SERVICE BULLETIN

SB00003A

SUBJECT: STARTER CIRCUIT: ISOLATOR SOLENOID

MODELS AFFECTED: CC11-100 S/N: 00001 through S/N00040

FIGURE 1 – SOLENOID HOLE LOCATION

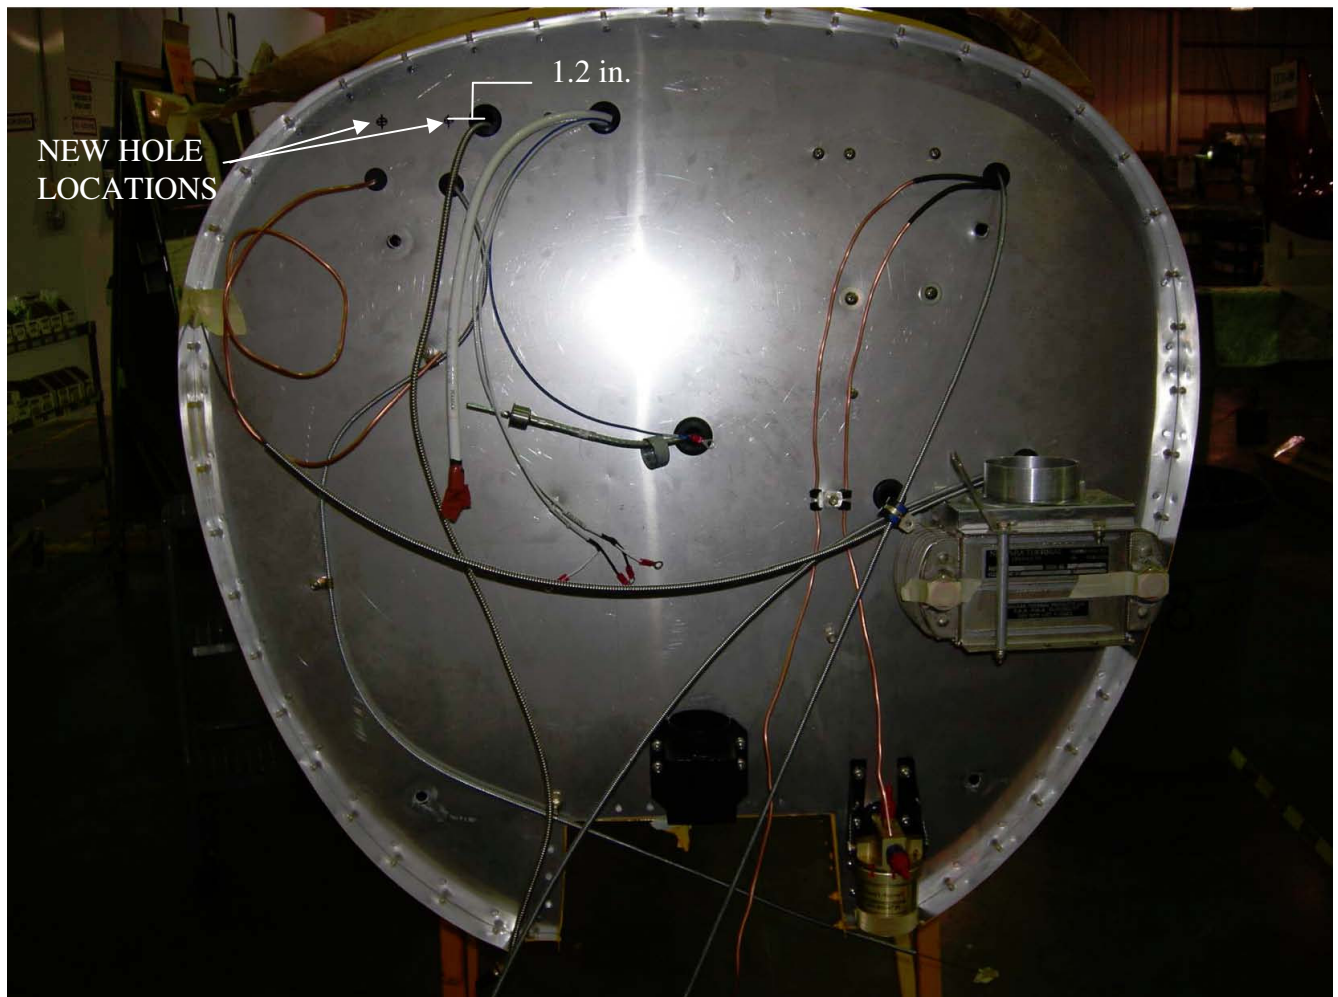
4. Remove 18AWG STARTER SWITCH WIRE (P05A18BL) from starter terminal.
Remove female spade terminal.
5. Pass disconnected wires through firewall grommet.
6. Mark hole locations on firewall per Figure 1. Use solenoid as a template.

7. Drill holes .250" (E) through firewall at marked locations.
8. Puncture holes through interior firewall insulation and covering to match previously drilled firewall holes.

FIGURE 2 – SOLENOID ATTACHMENT

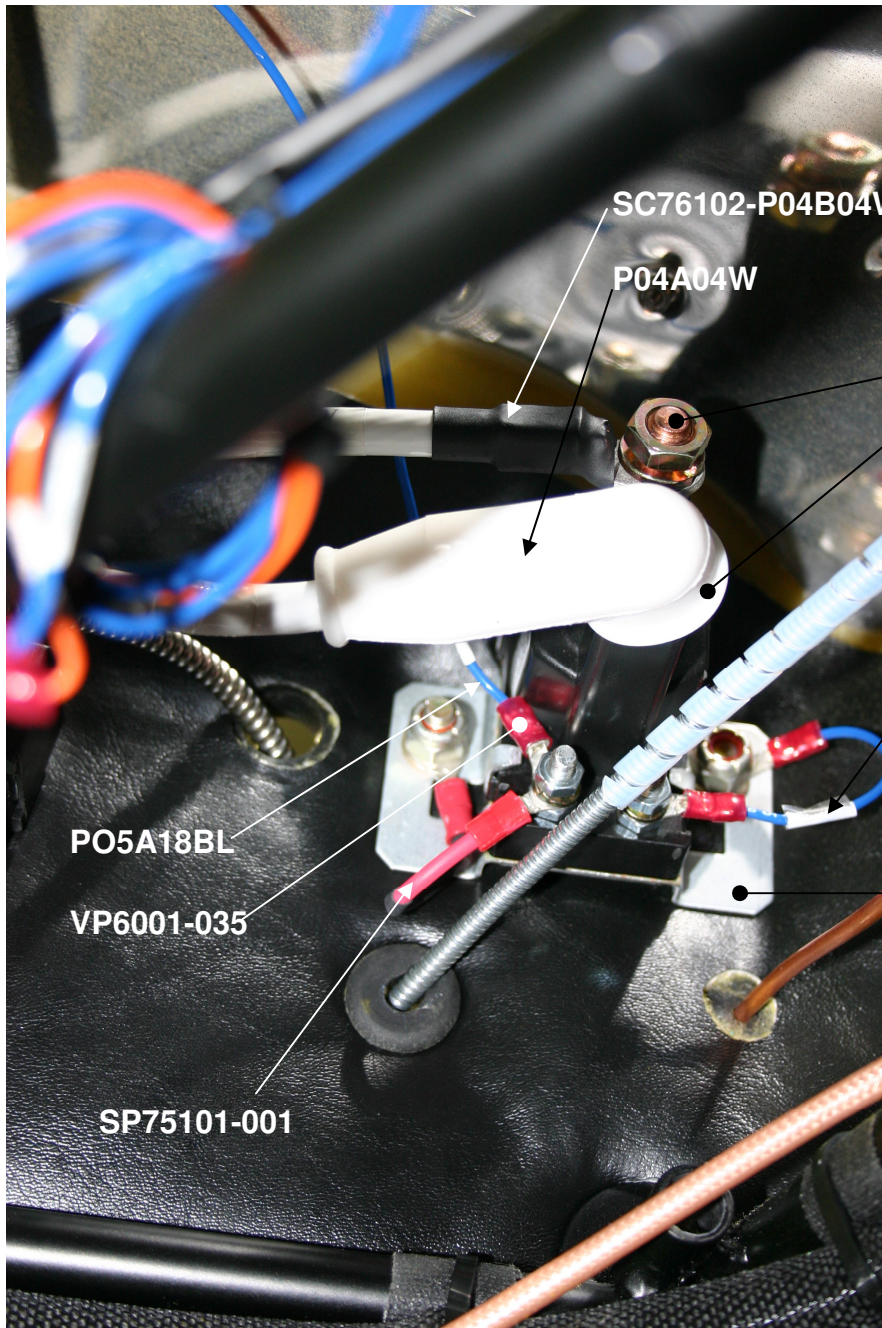
10. Secure WIRE ASSEMBLY (P/N SP76102-P08A18BL) to SOLENOID base with one (1) AN4-5A bolt, two (2) AN960-416 WASHERS, and one (1) AN365-428A NUT (REF FIGURE 2).

11. Secure DIODE ASSEMBLY (P/N SP75101-001) to solenoid base with previously installed AN4-5A BOLT, AN960-416 WASHERS, AN365-428A NUT (REFERENCE STEP 9) (REF FIGURE 2).

12. Install opposite end of WIRE ASSEMBLY (P/N SP76102-P08A18BL) to solenoid coil post with supplied solenoid hardware (REF FIGURE 2).
13. Install RING TERMINAL (P/N VP6001-035) on 18AWG STARTER SWITCH WIRE (P05A18BL).

14. Route and secure STARTER SWITCH WIRE (P05A18BL) and DIODE ASSY (P/N SP75101-001) to remaining solenoid coil post with supplied solenoid hardware (REF FIGURE 2).

17. Route and secure BATTERY CABLE (P04A04W) and WIRE ASSEMBLY (P/N P04B04W) to solenoid posts with supplied solenoid hardware.
18. Slide terminal covers over battery cable terminal and solenoid post (REF FIGURE 2).

FIGURE 3 – JUMPER WIRE CONNECTION

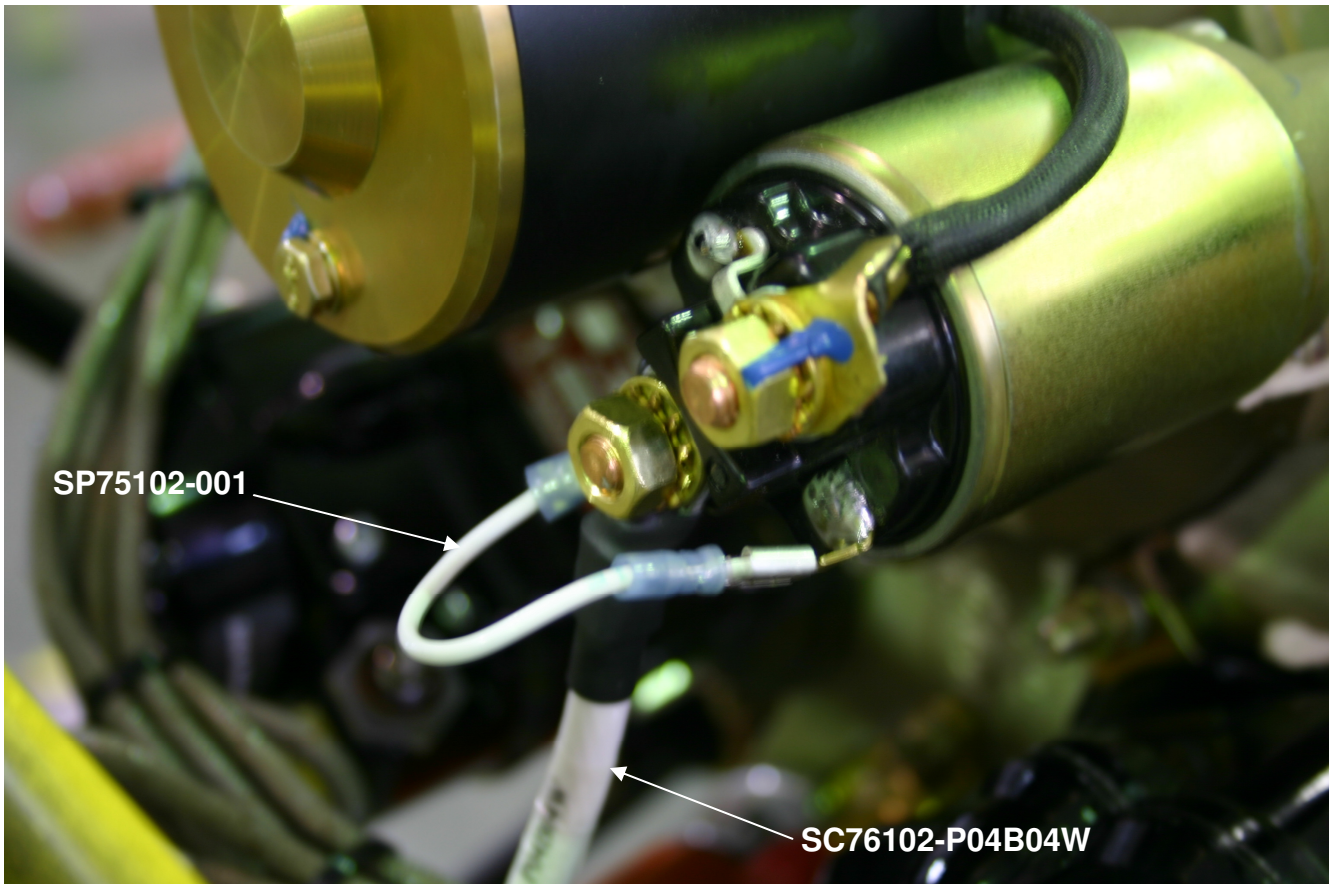
19. Install and secure JUMPER (P/N SP75102-001) and WIRE ASSEMBLY (P/N P04B04W) to starter solenoid post with original hardware (REF FIGURE 3).
20. Secure opposite end of JUMPER (P/N SP75102-001) to starter solenoid terminal (REF FIGURE 3).
